Subject: Federal Inspection, July 18, 1979

My response to highlighted Items 8 and 12 in Federal Report,
Minn.-18 (HP) Health Sciences Expansion B/C is as follows:

Subject: BC Phase I Federal Inspection (restroom identification)

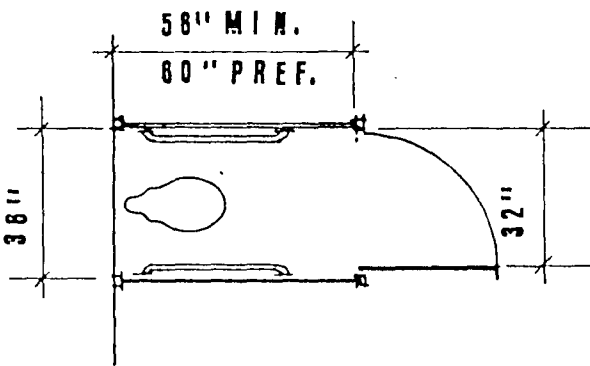
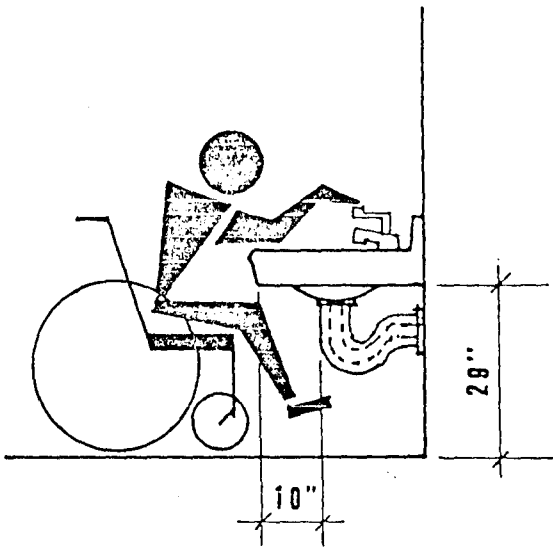
- ✓ a. Steps shall not have square or abrupt nosings.
- * b. Stairs shall have handrails 32 inches high measured vertically from the stair nosing. At least one handrail must extend at least 18 inches beyond both the top and the bottom step.

* Trog is 14"
Bottom over 18"

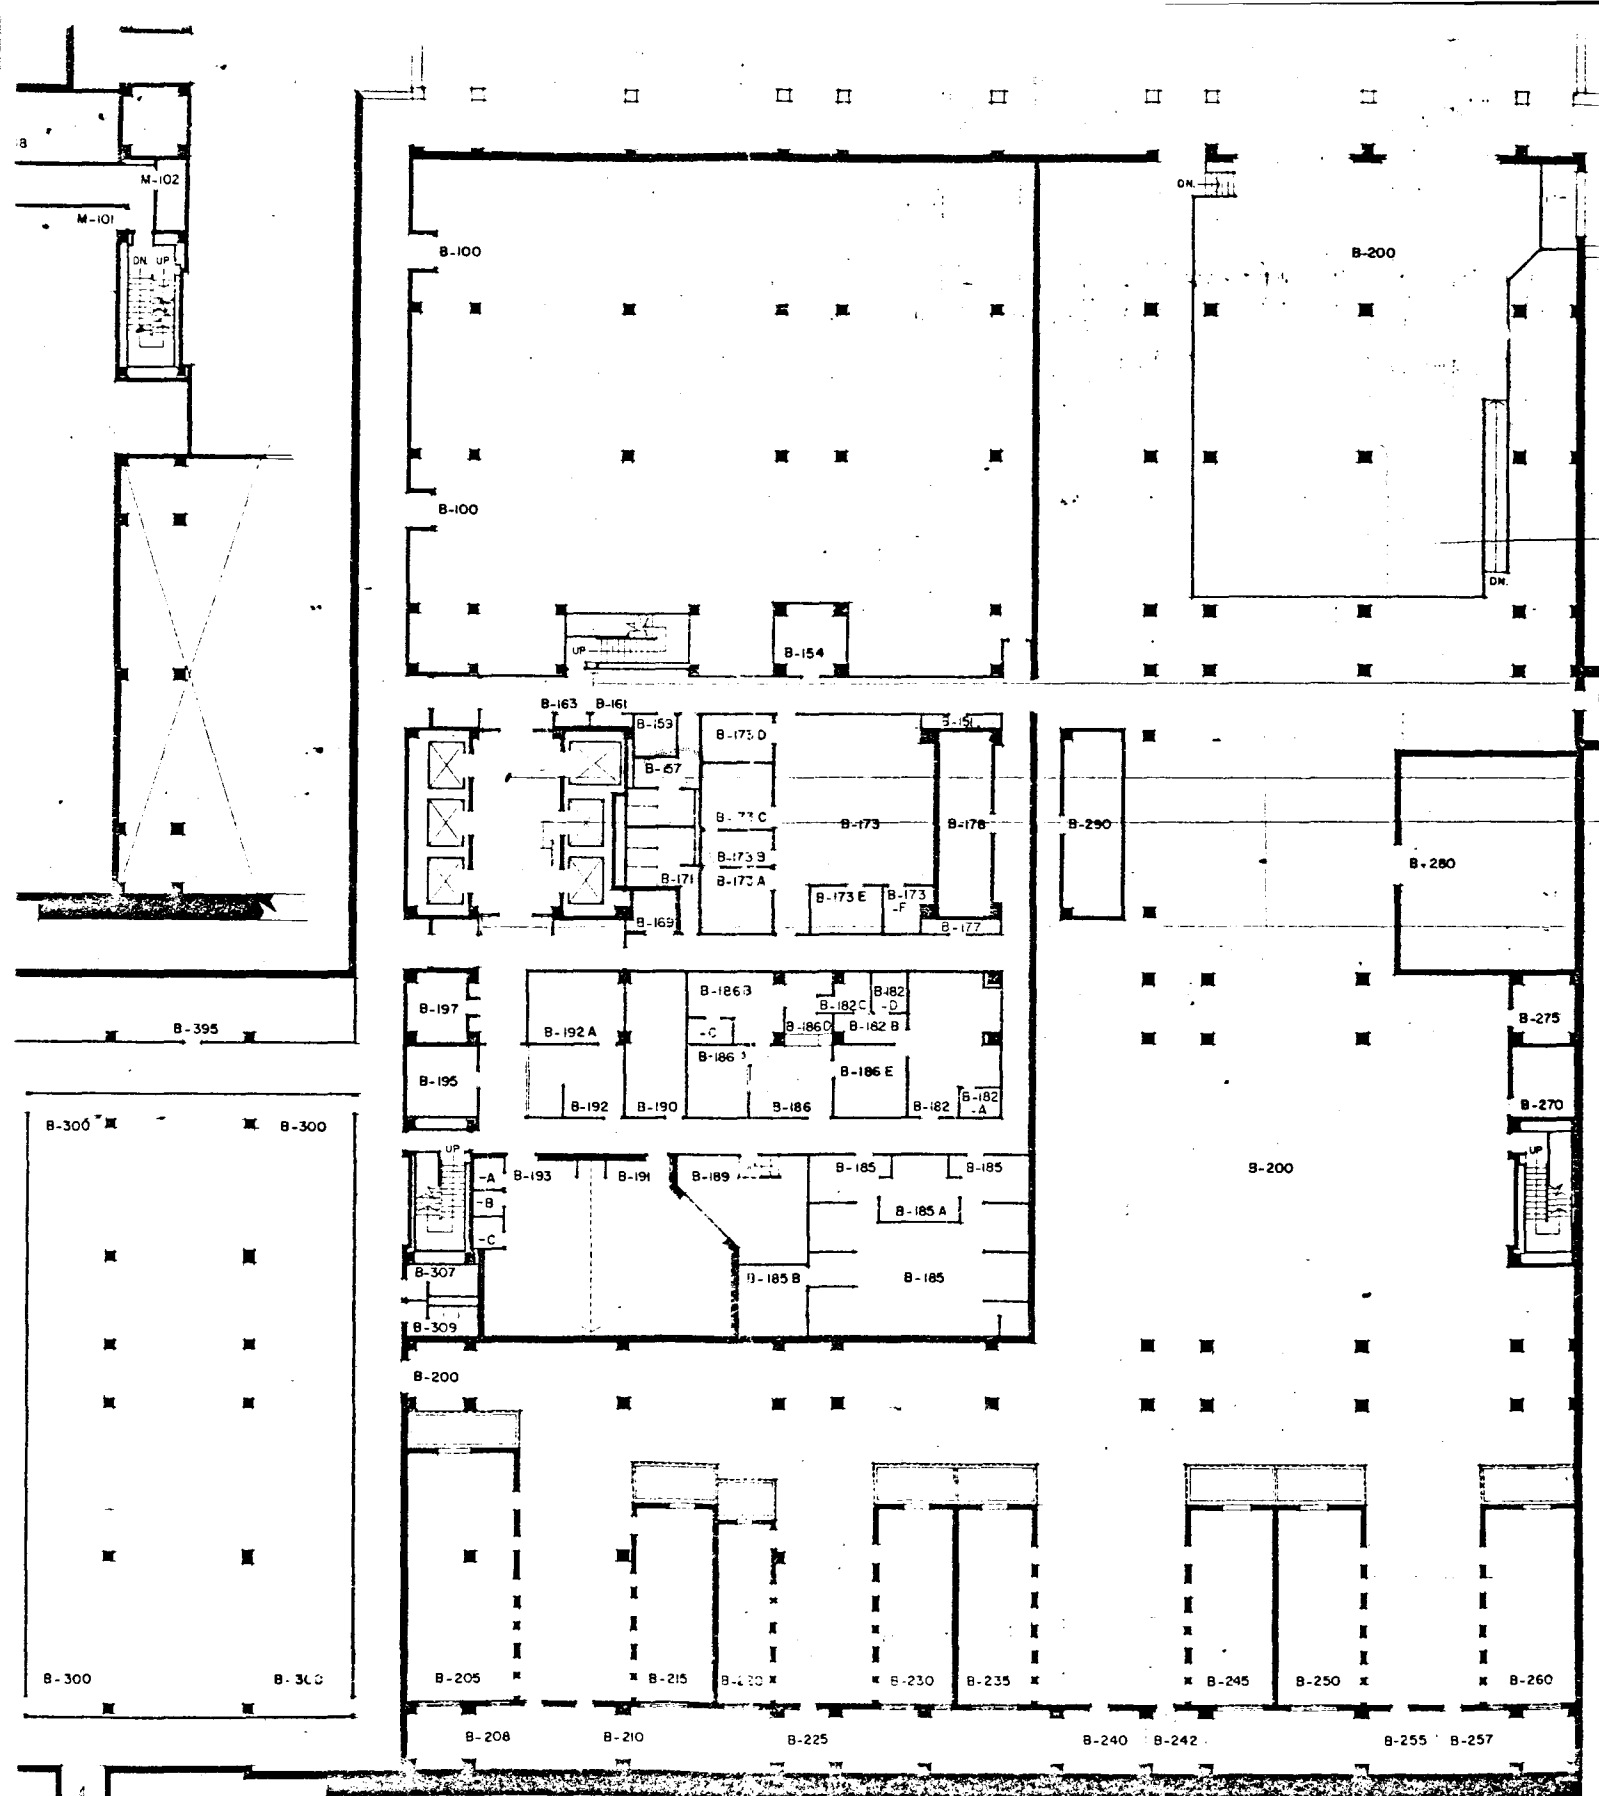
In reference to your inquiry into the identification of the handicapped facilities in BC, I presume that the deficiencies are in the lack of a handicapped symbol for the restrooms internal to the clinic waiting areas. The major public restrooms fronting corridors were identified with the acrylic signs, featuring raised copy and screened handicapped symbol.

The restroom signs for the areas internal to the clinics can be modified by providing appropriate inserts for the sign holders. I have ordered inserts for the signs as noted on the attached plan set, and will have them installed. This should be corrected within a week or so.
